**DRAFT AMENDMENT
FOR PUBLIC COMMENT**

Draft Amendment No. 1 to

Singapore Standard SS 550 : 2020 – Code of practice for installation, operation and maintenance of electric passenger and goods lifts

AMENDMENT NO. 1

Figure F.1 – Fixed pit ladder

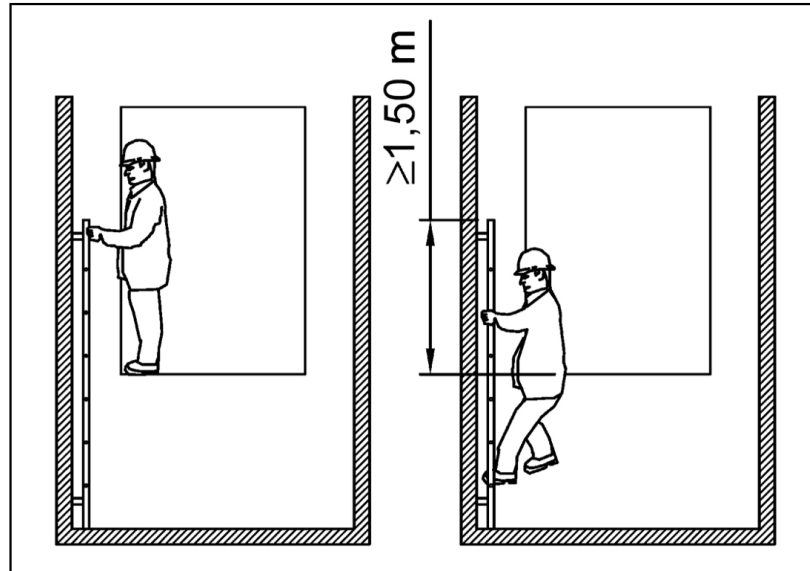
13. Page 192, Figure F.1

Replace with the following figure:
